**From:** Service Manager Environment      **To:** Head of Environment and Planning  
**Our Ref:** EP/DC/PP/2017/0404      **Your Ref:** MR/P/2017/0404  
**Date:** 1<sup>st</sup> June 2017

**Location:** O. S Grid Ref: 348 546 Balmuir Garage, 1 Chester Road, Gresford, Wrexham.

**Development:** Outline application for the erection of up to 12 dwellings and construction of vehicular access.

I refer to your consultation dated 18/05/2017 including layout plan (Drg. No. B113/004 – Dated March 2017) in respect of the above.

## Turning Areas

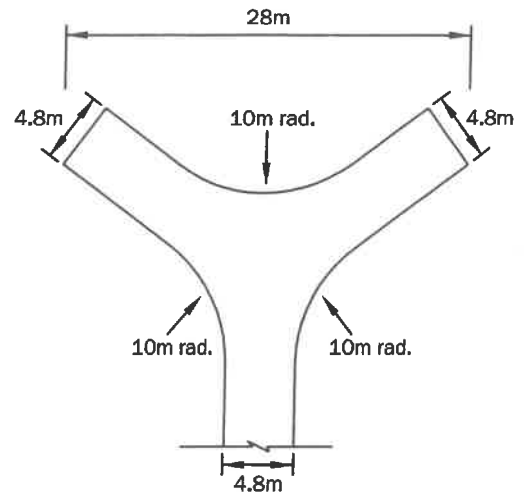
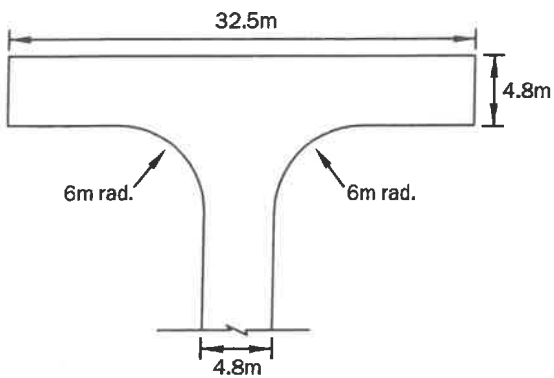
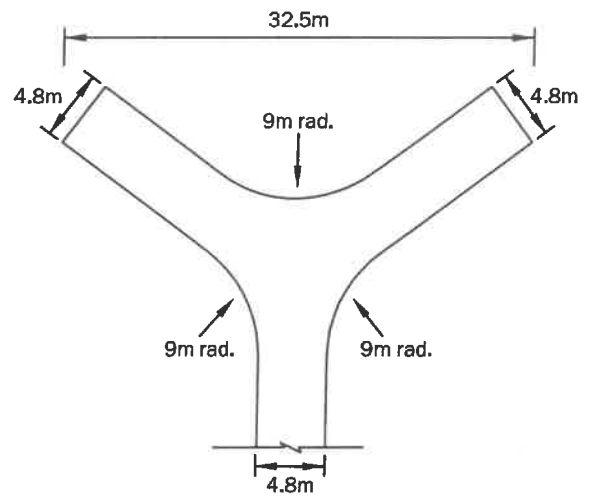
- The proposed turning heads will need to comply with current adoptable standards (see attached detail). The turning heads indicated on the submitted layout plan are of insufficient size to accommodate the turning movements of an 11.2m long refuse vehicle. I understand from the applicant that a refuse vehicle can currently enter and turn within the existing garage site.
- The provision of 2 parking spaces per 2 bedroom dwelling is considered adequate.

Turning areas are based on an 11.18m long, 2.55m wide refuse vehicle.
